Access Compliance Report

Public Rights-of-Way

Intersection ID: 10019976	Main Street: ARENA_BV	Cross Street: N/A	Location: E
ADA ID: 14CD4BCF57A4	Ramp Type: BlendTrans1	Initial Pass/Fail: Fail	Overall Compliance: No
Severity Score: 12.5			
Codes/Mitigation Info/Possible Solution		Field Measurements/Component Compliance

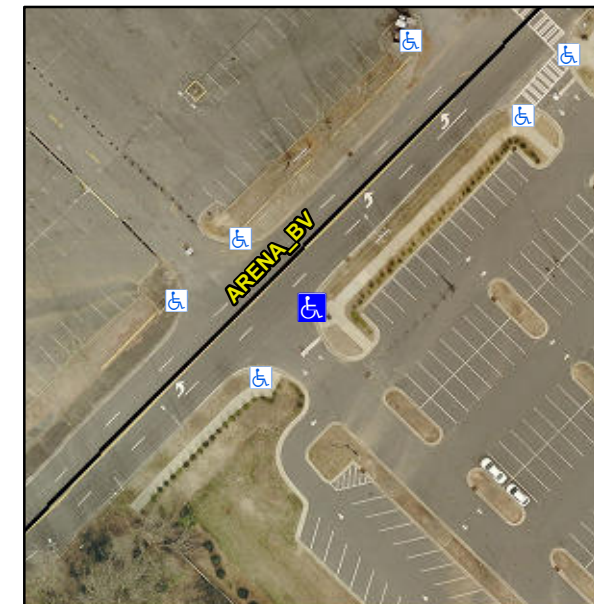
Not Found, R304.5.3

Compliance	Description	Data	Compliance	Description	Data
N/A	Ramp Length (in)	98.0	Yes	BlendTrans Slope (%)	0.5
Yes	Ramp Width (in)	60.0	No	BlendTrans XSlope (%)	5.7
N/A	Flare Type LT	N/A	N/A	Flare Type RT	N/A
N/A	Flare Slope LT (%)	N/A	N/A	Flare Slope RT (%)	N/A
N/A	Flare Traversable LT?	N/A	N/A	Flare Traversable RT?	N/A
N/A	Landing Length (in)	N/A	N/A	DWS Provided?	N/A
N/A	Landing Width (in)	N/A	N/A	DWS Contrast?	N/A
N/A	Landing Slope (%)	N/A	N/A	DWS Length (in)	N/A
N/A	Landing X Slope (%)	N/A	N/A	DWS Full Width?	N/A
N/A	Landing Curb? (Y/N)	N/A	N/A	DWS Offset (in)	N/A
N/A	Shared Landing?	N/A			
N/A	Gutter Ponding?	N/A	N/A	Gutter Slope (%)	N/A
N/A	Gutter Lip Ht (in)	N/A	N/A	Gutter X Slope (%)	N/A
N/A	Painted X Walk1?	No	N/A	Painted X Walk2?	No
	X Walk 1 Direction	To NW		X Walk 2 Direction	To SW
	X Walk 1 Width (in)	N/A		X Walk 2 Width (in)	N/A
	X Walk 1 Slope (%)	0.2		X Walk 2 Slope (%)	7.9
	X Walk 1 X Slope (%)	6.7		X Walk 2 X Slope (%)	0.2

N/A	Ramp inside XWalk1?	N/A	N/A	Ramp inside XWalk2?	N/A
	Road Slope (%)	3.3		Clear Space?	N/A
	Road X Slope (%)	6.5	N/A	Clear Space to XWalk (in)	N/A
N/A	Any Obstructions?	N/A	N/A	Storm Grate/Utility Hazard?	N/A
	Obstruction Type			Storm Grate/Utility Type	
		N/A			N/A
			Yes	Surface Condition? (G/P)	Good
			No	Curb Slope (%)	12.4

Remove & Replace Curb Ramp With Two New Directional Ramps or Equivalent.
